Intel[®] Pentium[®] III Processor Specification Update

Release Date: May 2005

Document Number: 244453-055

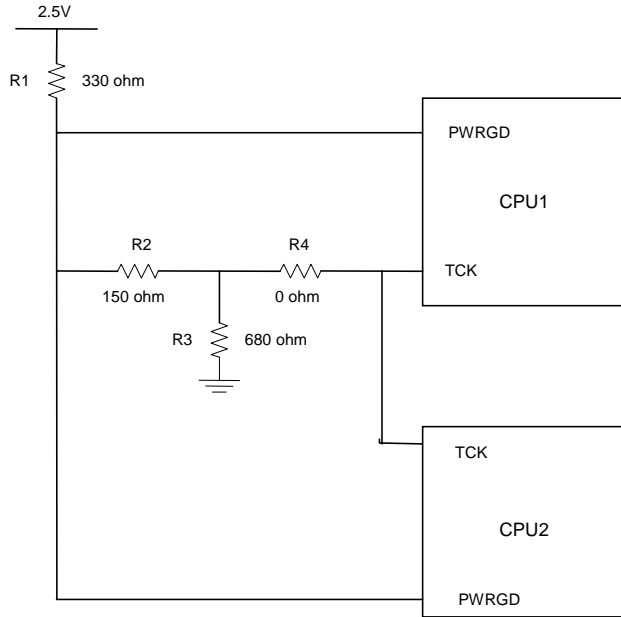
Problem: The internal control register bit responsible for operation of the Thermtrip circuit functionality may power up in a non-initialized state. As a result, THERMTRIP# may be incorrectly asserted during de-assertion of RESET# at nominal operating temperatures. When THERMTRIP# is asserted as a result of this erratum, the processor may shut down internally and stop execution but in few cases continue to execute.

Implication: This issue can lead to intermittent system power-on boot failures. The occurrence and repeatability of failures is system dependent, however all systems and processors are susceptible to failure. In addition, the processor may fail to stop execution during the event of a valid THERMTRIP# assertion resulting in the potential for permanent processor damage.

Workaround: To prevent the risk of power-on boot failures or catastrophic thermal failures, a platform workaround is required. The system must provide a rising edge on the TCK signal during the power-on sequence that meets all of the following requirements:

- Rising edge occurs after Vcc_core is valid and stable
- Rising edge occurs before or at the de-assertion of RESET#
- Rising edge occurs after all Vref input signals are at valid voltage levels
- TCK input meets the Vih min and max spec as mentioned in EMTS
